J JACKSON | MAIN **Cubix - Fremont**

Cubix - Fremont

BOARD RECOMMENDED CONDITIONS

Cubix Fremont Apartments 3519 Fremont Place North Seattle, WA 98103

NORTH ELEVATION

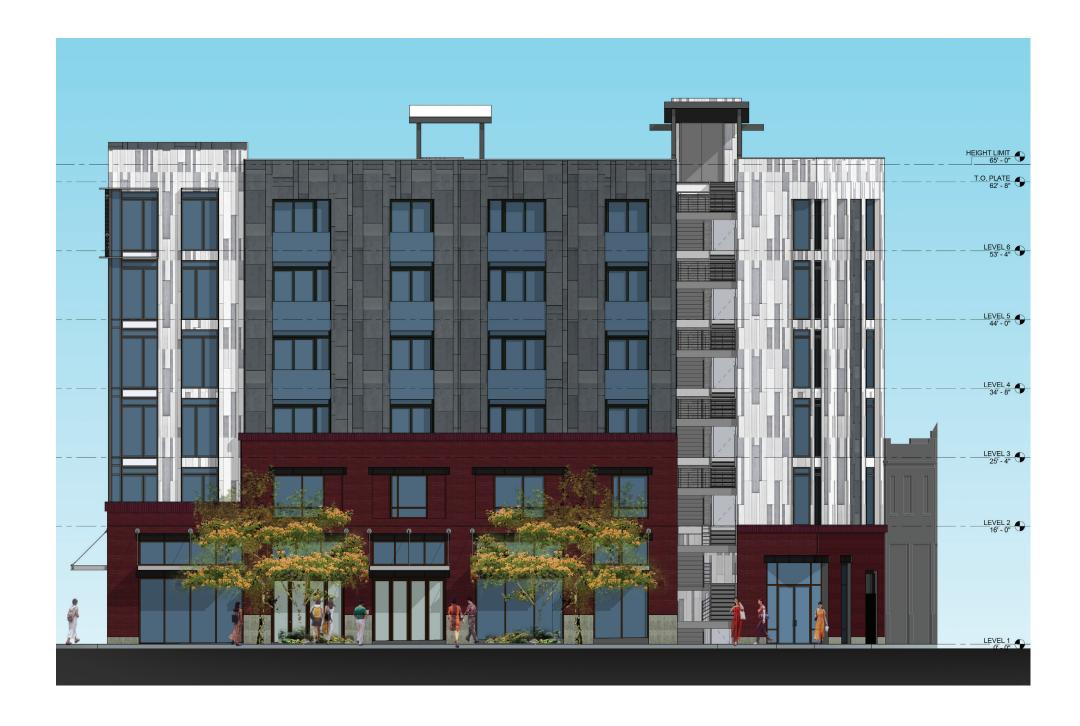
- The white vinyl windows on the northern façade should be darker, similar to the rest of the upper level windows or the area near the white windows should be lightened to be more of an intentional, light expression at that location. (DC4-A, DC2-C, DC2-B-1)

- Further develop the northwest corner façade composition to better integrate the podium with the upper levels. This could be achieved in a number of ways including possibly pulling the materiality of the upper levels down through the brick base, modifying the corner parapet coping, and/or using the larger scaled corner signage to better integrate the podium with the upper levels. (DC2-B-1, CS3-A, CS2-A, CS2-C-1)

- Modify the rooftop canopies above the stair towers to better integrate into the overall building composition and explore opportunities to incorporate the stair tower art and canopies. (CS2-A, CS3-A, PL2-C-2, DC2-C)

- The large-scale signage proposed at the NW corner should be high quality and artistic, similar to the existing eclectic signage character in the neighborhood. Signage lighting should be designed to minimize light and glare impacts to adjacent units. (DC4-B, DC4-C, DC2-C)

WEST ELEVATION

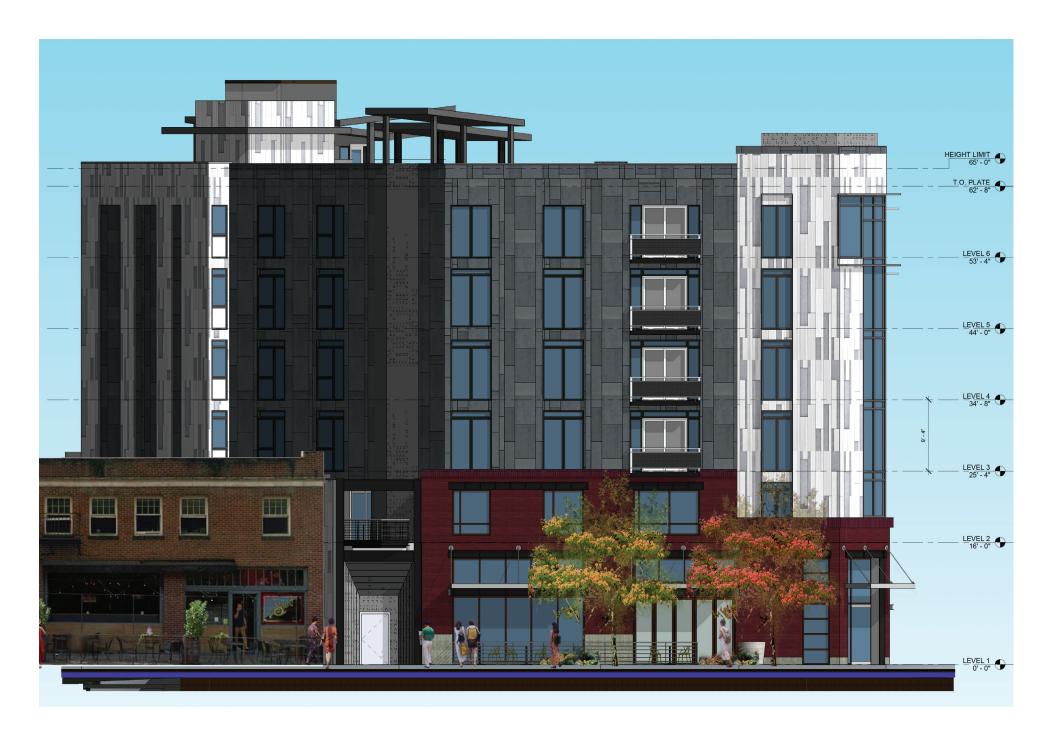
- The white vinyl windows on the northern façade should be darker, similar to the rest of the upper level windows or the area near the white windows should be lightened to be more of an intentional, light expression at that location. (DC4-A, DC2-C, DC2-B-1)

- Modify the proportions of the brick base on the southfacing, N 35th Street façade to better relate to the other facades and datum of the adjacent building. The brick base should have the same level of detailing and depth as the other facades including a brick solider course and steel lintels. (DC2-B-1, CS3-A, CS2-A)

- Further develop the northwest corner façade composition to better integrate the podium with the upper levels. This could be achieved in a number of ways including possibly pulling the materiality of the upper levels down through the brick base, modifying the corner parapet coping, and/or using the larger scaled corner signage to better integrate the podium with the upper levels. (DC2-B-1, CS3-A, CS2-A, CS2-C-1)

- Modify the rooftop canopies above the stair towers to better integrate into the overall building composition and explore opportunities to incorporate the stair tower art and canopies. (CS2-A, CS3-A, PL2-C-2, DC2-C)

- Further develop the art at the stair tower to be well integrated into the overall fabric of the building and minimize light and glare to units within and near the project. (DC4-A-1, DC4-C, DC2-C)

N-E ELEVATION

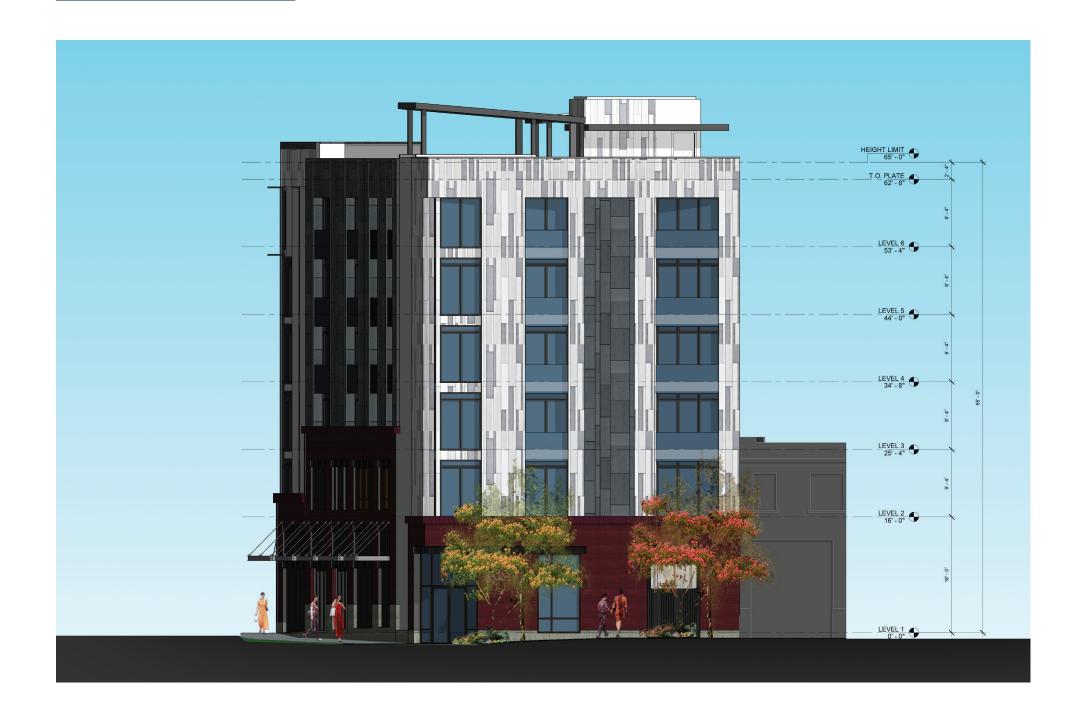
- A The white vinyl windows on the northern façade should be darker, similar to the rest of the upper level windows or the area near the white windows should be lightened to be more of an intentional, light expression at that location. (DC4-A, DC2-C, DC2-B-1)

- Further develop the northwest corner façade composition to better integrate the podium with the upper levels. This could be achieved in a number of ways including possibly pulling the materiality of the upper levels down through the brick base, modifying the corner parapet coping, and/or using the larger scaled corner signage to better integrate the podium with the upper levels. (DC2-B-1, CS3-A, CS2-A, CS2-C-1)

- Modify the rooftop canopies above the stair towers to better integrate into the overall building composition and explore opportunities to incorporate the stair tower art and canopies. (CS2-A, CS3-A, PL2-C-2, DC2-C)

- The large-scale signage proposed at the NW corner should be high quality and artistic, similar to the existing eclectic signage character in the neighborhood. Signage lighting should be designed to minimize light and glare impacts to adjacent units. (DC4-B, DC4-C, DC2-C)

SERVICE USES

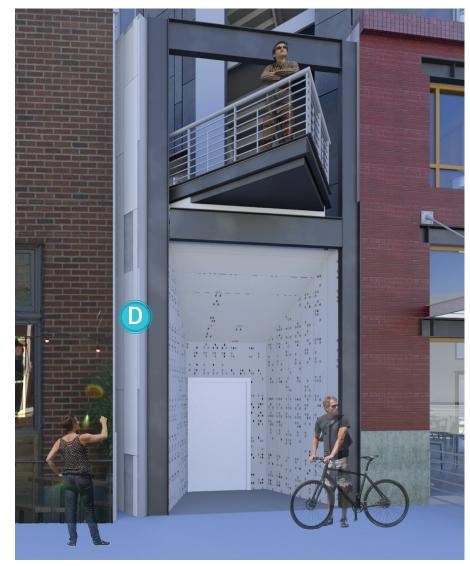
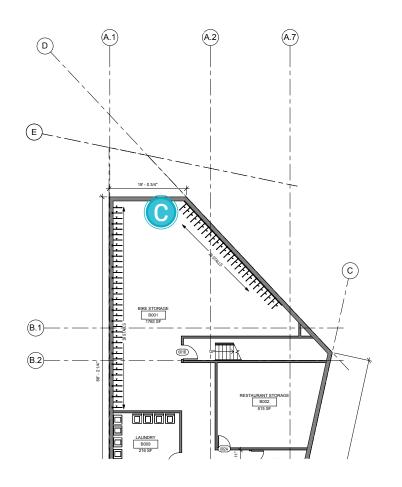
The Board recognized the east elevation would likely be visible for the foreseeable future and expressed concern with the blank wall portion of that façade. The Board directed the applicant to explore options such as an artistic mural, or use of materials and/or colors to add interest to the blank wall.

The board expressed concern with the location and negative impacts of the service uses on the N35th St. and stated a strong preference for the service use area to be fully enclosed. The space should be designed to minimize impacts to the pedestrian environment including adequate screening. For the recommendation meeting, the applicant should provide additional detail on the service area, including proposed screening materials and a street-level perspective of the N 35th St. street-level facade. The applicant must demonstrate how the service area design will successfully mitigate negative impacts without fully enclosing the space.

- The building language that was developed on the West and East Facades has been applied to this wall with a change in depth and material to continue the modulation with materials and shadow.
- A slanted gate that is designed to be visually open when seen from the east and closed when seen from the west.
- Residential entrance has been moved to the corner of the building, both accentuating it and further distancing it from the trash pick-up gate.

LIGHTING

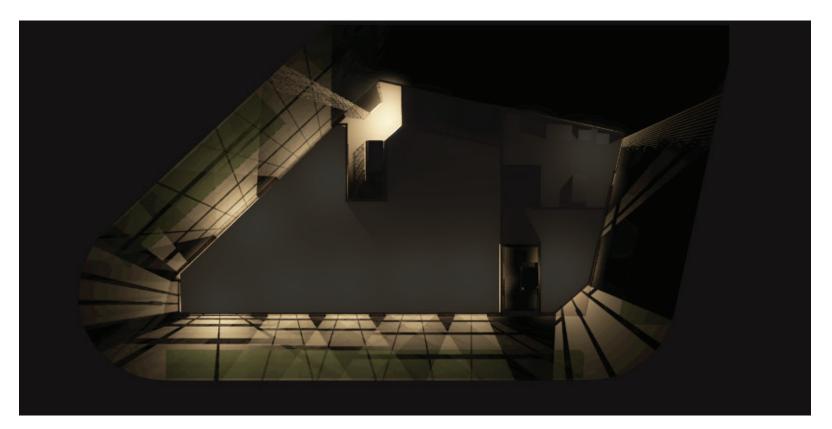
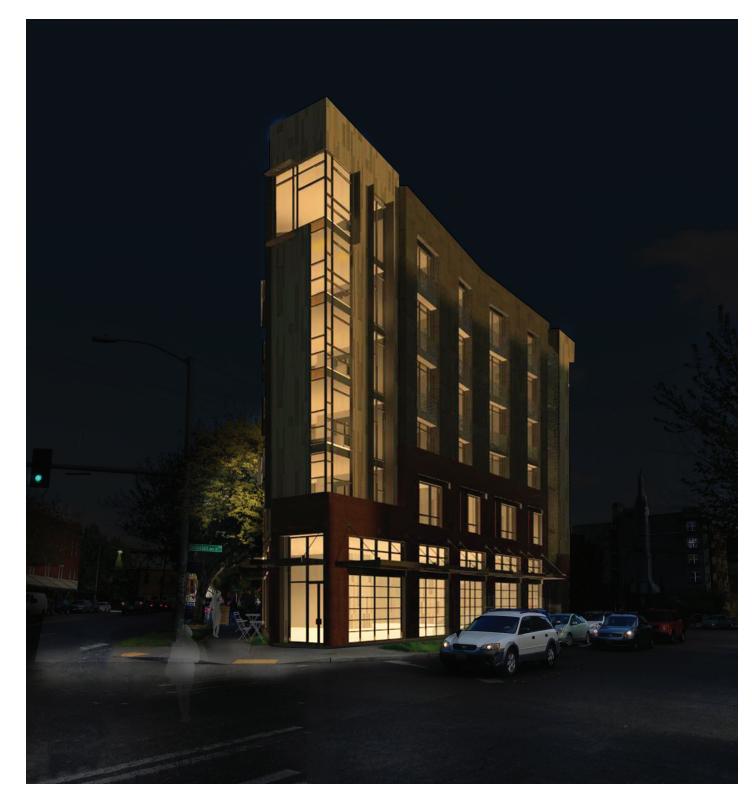
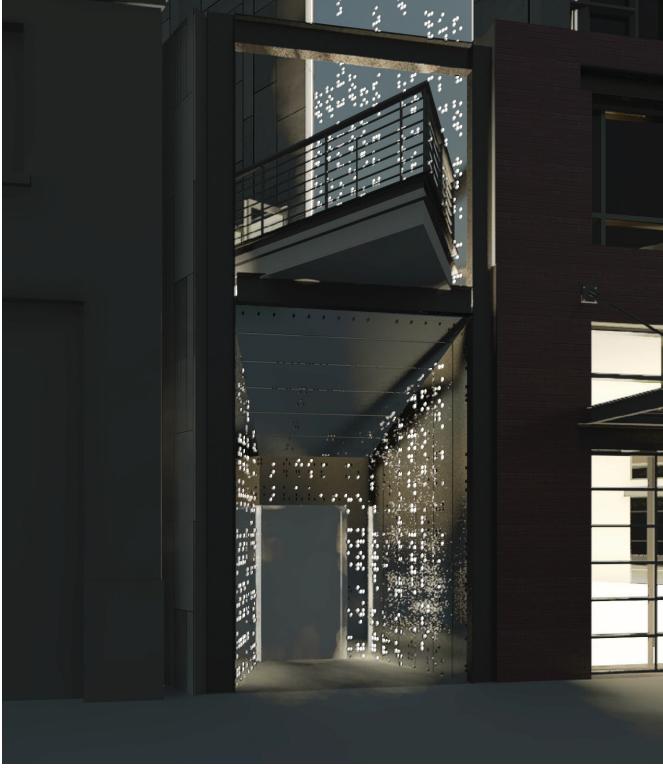
For the Recommendation meeting, the applicant should provide a signage and lighting plan. Lighting and signage should be well thought out and should add interest to the streetscape, enhancing entries and landscaping. (PL2-C, PL3-A, DC4-B-1, DC4-B&C)

Lighting will be provided from the canopies to both illuminate the facade and provide a safe and pleasant pedestrian experience.

SIGNAGE

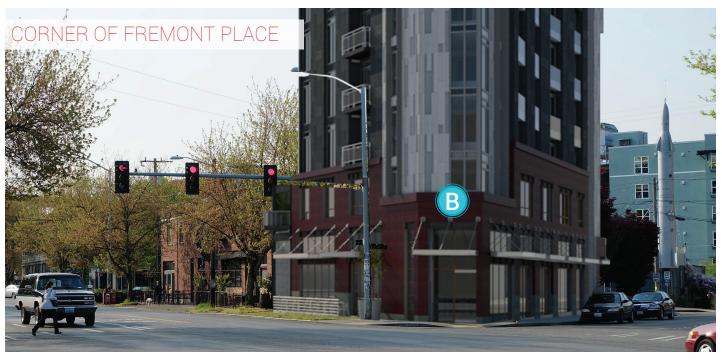
For the Recommendation meeting, the applicant should provide a signage and lighting plan. Lighting and signage should be well thought out and should add interest to the streetscape, enhancing entries and landscaping. (PL2-C, PL3-A, DC4-B-1, DC4-B&C)

Signage for the commercial space will occur on the northern 'prow' and at the residential entry. There will be a large art piece located in the stairwell of the SW corner adjacent to the residential entrance.
